Addendum 004

31 Unit HVAC Replacement Program: NC 20-2 Wilson Housing Authority

Monday, 03/24/25

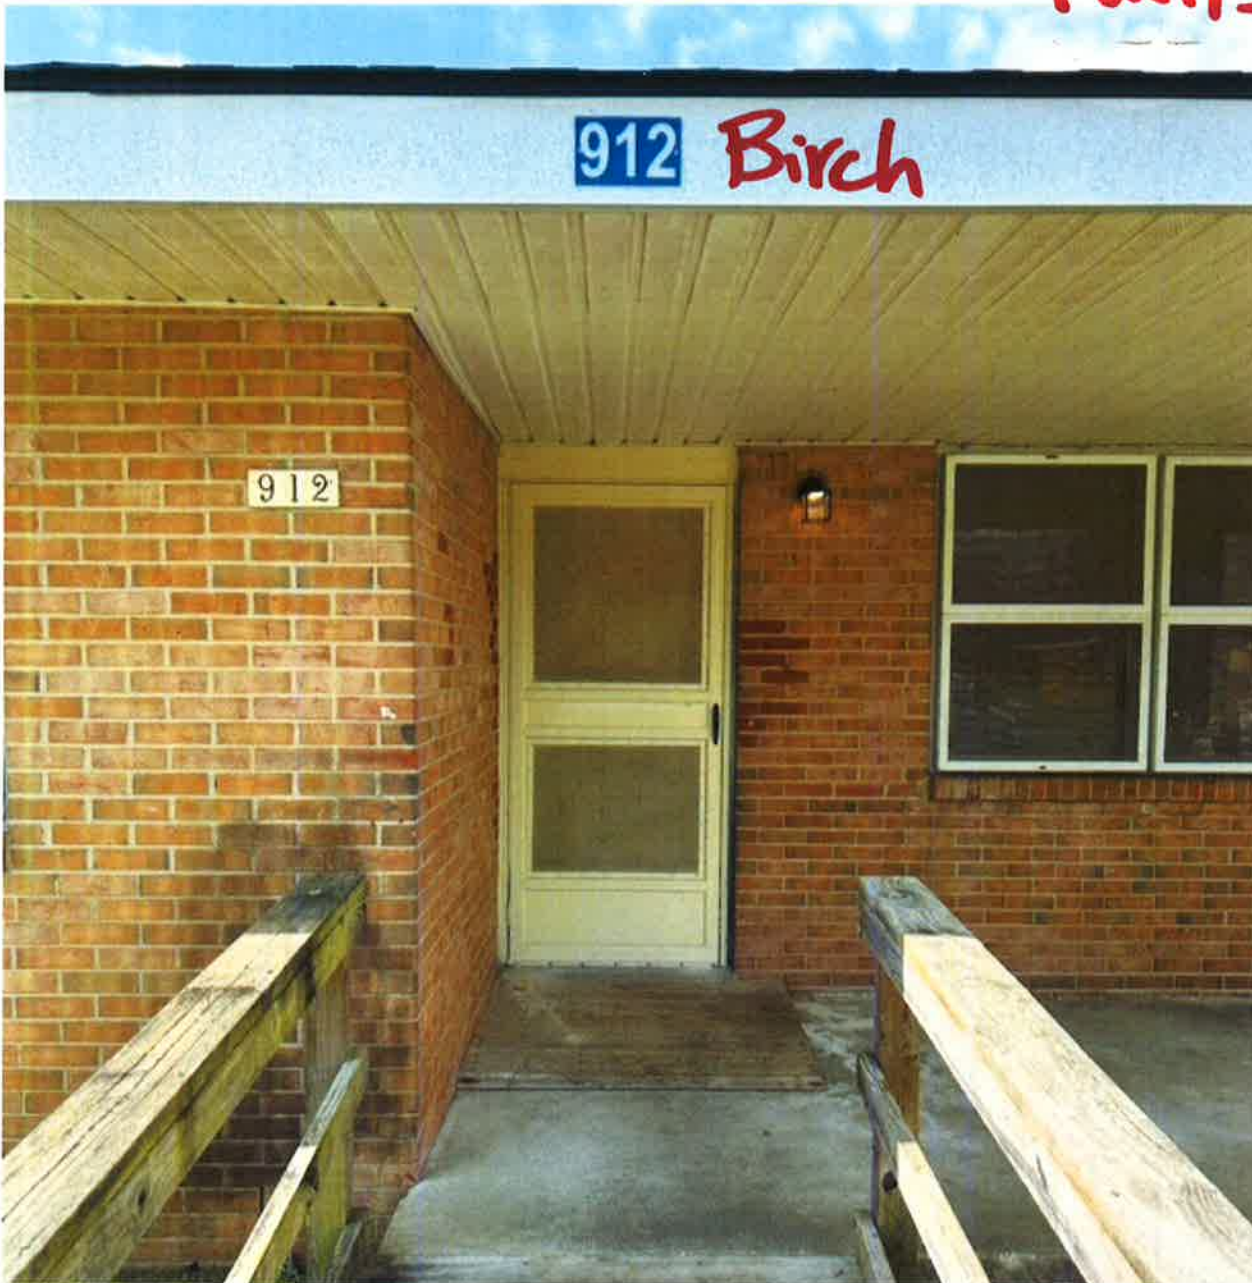
- We installed the water heater in 912 Birch instead of 911 Birch since it's the same #1 type and recently became vacant.
- We picked up 2" from removing the gas line from the left side of the water heater and picked up 2" by straightening the water heater getting the pop off valve out of the way.

- The sheet metal on the wall is not required due to the minimum clearance from combustible or non-combustible construction, zero (0) inches sides, zero (0) inches back and eight (8) inches top. See attached pictures.

- Please include in your bid changing out the other 8 water heaters for type #1 units.
- I have attached pictures of the A. O. Smith water installed @ 912 Birch (Model #GCB-40-400) (18" in diameter).

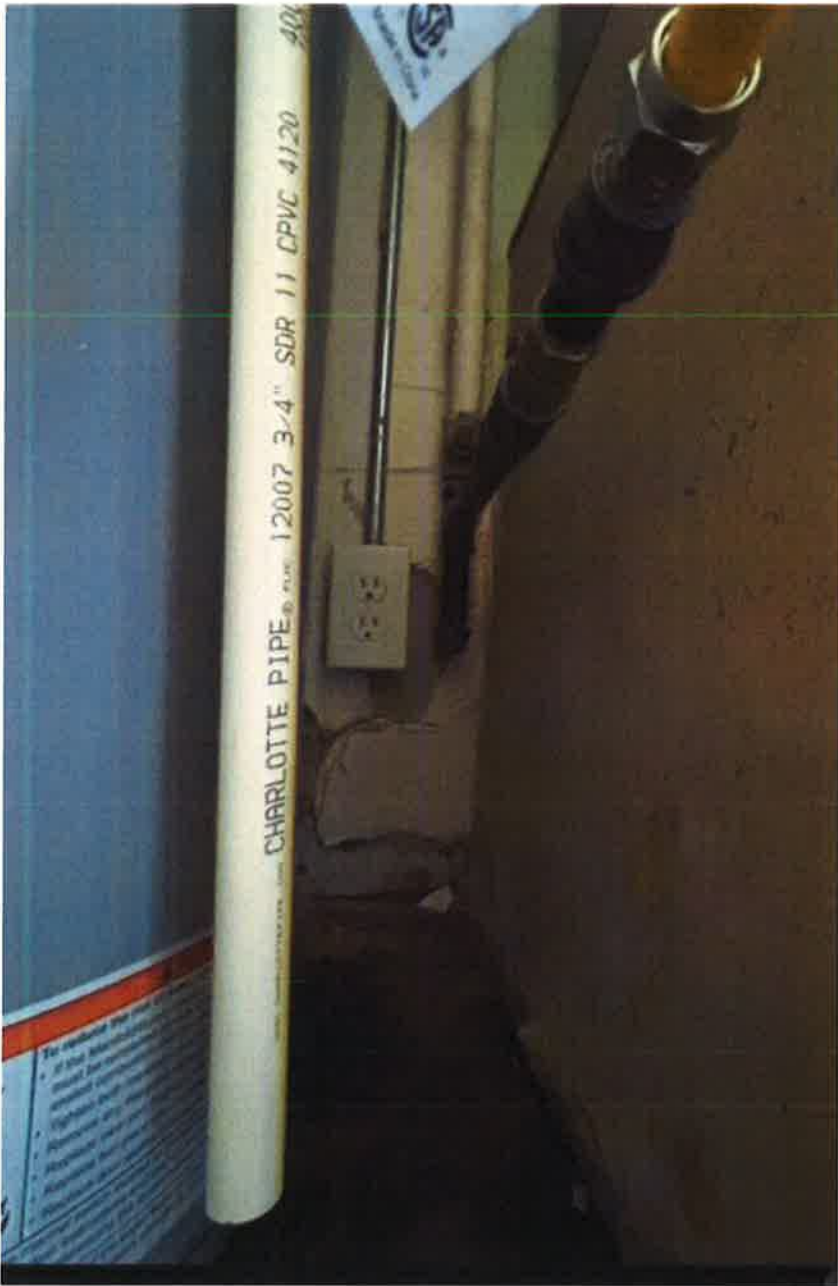
Appropriate installation:

- This appliance must be installed in accordance with local codes or, in the absence of local codes, the National Fuel Gas Code, ANSI Z223.1/NFPA 54.
- Minimum clearances from combustible or non-combustible construction, 0 inches sides, 0 inches back and 8 inches top. For closet installation, 4 inches front. A minimum of 4 inches is required for access to serviceable parts such as the drain valve, relief valve and thermostat.
- This flammable vapor resistant water heater must be
